SERVICE LETTER

No. 784

Piper Aircraft Corporation

Subject: Landing Gear Hydraulic System Refinement

VIEW LOOKING DOWN AT HYDRAULIC SYSTEM

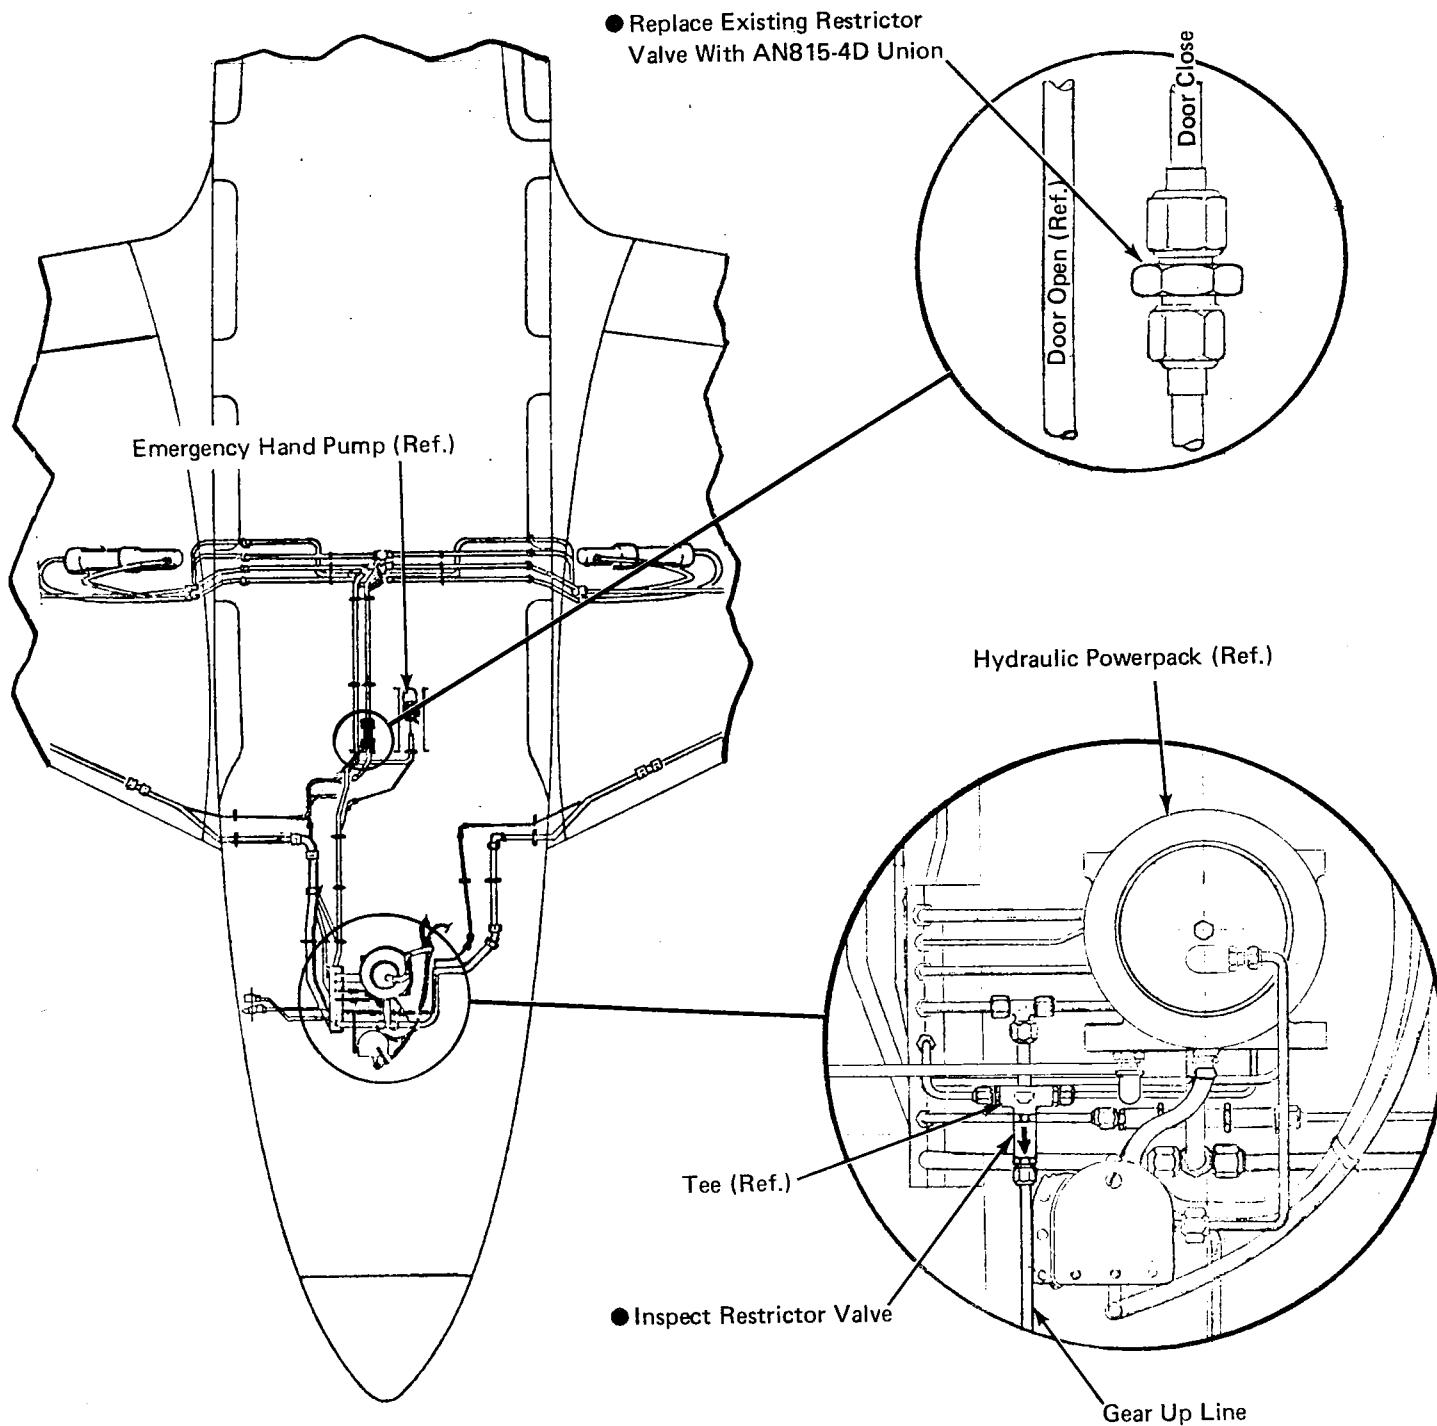
A report has been received from the field describing an incident in which the main landing gear doors on an early PA-31 Navajo failed to open during landing gear extension. This condition was found to have been caused by an internal failure of the "Door Close" hydraulic line restrictor valve. One later model Navajos, this valve was replaced by a union coupling, and replacement is herein recommended for the above referenced aircraft (reference attached sketch/instruction sheet and Material Required No. 1, below).

Further, a second restrictor valve is located in the "Gear Up" hydraulic line (adjacent to the powerpak) and may be subject to the same internal failure, depending on the type of valve installed. This service release recommends an inspection (and replacement, if required - see attached sketch/instruction sheet and Material Required No. 2, below) to refine the subject system on the above referenced aircraft in accordance with current production configuration.

- A. Remove the center floorboard from the forward cockpit to gain access to the hydraulic lines forward of the main spar.
 1. Locate restrictor valve in "Door Close" hydraulic line. Remove valve and install AN815-4D union (P/N 491 050) as shown.
- B. Remove access panels from both sides of fuselage nose section to gain access to hydraulic powerpack.
 1. Locate restrictor valve in tee of "Gear Up" line and inspect to determine manufacturer of valve (company name appears on valve placard).
 - a. If TACTAIR appears on valve, no further action is required.
 - b. If TAVCO INC. appears on valve, replace with new valve P/N 484 459 as shown.
- C. Add hydraulic fluid to the powerpack and bleed the hydraulic system. Check to ensure there are no leaks.
- D. Reinstall fuselage access panels and center floorboard.
- E. Make proper logbook entry of Service Letter 784 compliance.
